To All Customer

Ref no: 000115

Concerning Part Name : 0603 Series as the following table,

Product Type : Chip Inductor

Packing Specification

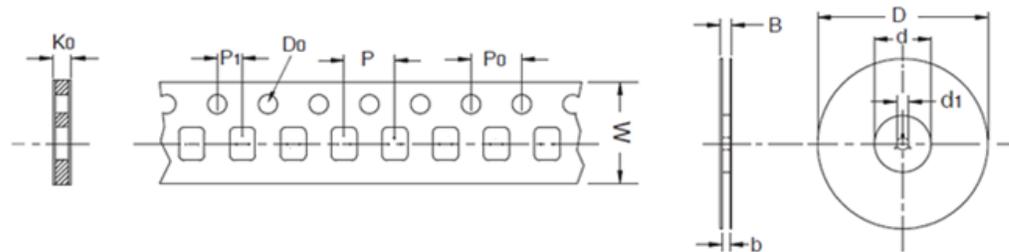
Classification of Change : Packing material

Description of Change : Change from embossed plastic to paper carrier tape. Details of paper tape dimensions see below in the table.

Packing Specification in paper tape:

Type	Packing Code	D	Do	d	d1	B	b	W	P	P0	P1	Ko	T
0603	01,08	180	1.55	60	13	12.7	8.4	8	4	4	2	0.97	1.05
0603	04	330	1.55	100	13	14.4	8.4	8	4	4	2	0.97	1.05
